Part 21 Report No: P21-04302015, Rev. 1

Subject: **Update** - Report of potential 10CFR Part 21, Allen Bradley Timing Relay Model 700RTC – NRC Event Number 51030, Accession Number ML15134A016

Figure 2 - New design circuit board and CPLD that replaced the original component.

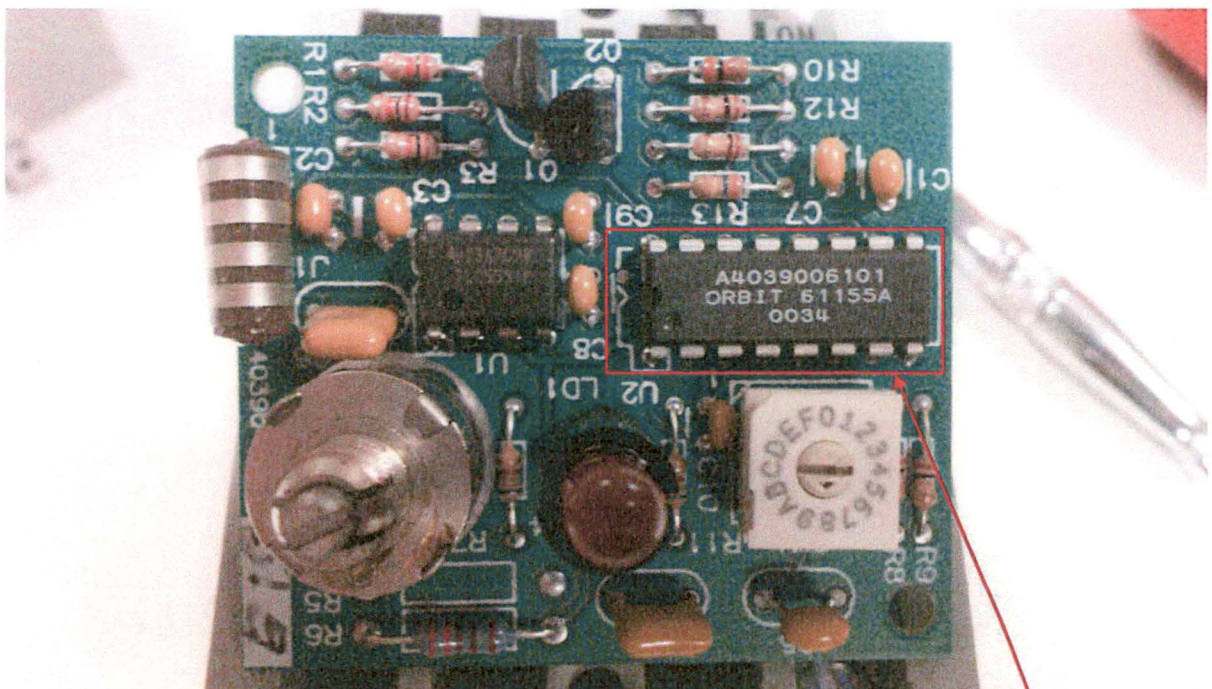
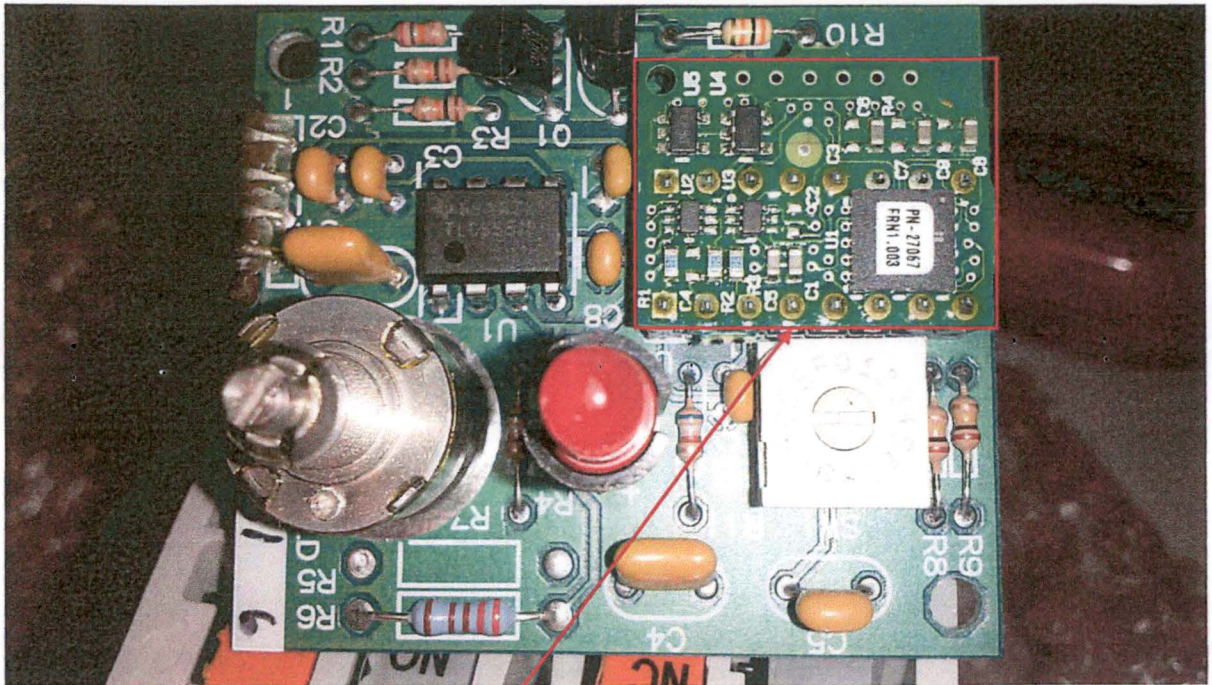
Between 2009-2010, Allen Bradley made a design change without changing the part number of the commercial relay or providing any documented evidence of a design change. The manufacturer specification data sheets maintain the classification that the relays are “solid state”, which would imply that there are no digital devices installed in the relay. However, after inspection of the internals of the timing relay (Figure 2), it has been identified that the unit does contain a CPLD which meets the definition of a digital device under the guidance of NEI 01-01. See Figures 1 and 2 below:

Figure 1- Original qualified design (prior to 2009).
Relays supplied prior to 2009 are not affected by this issue.
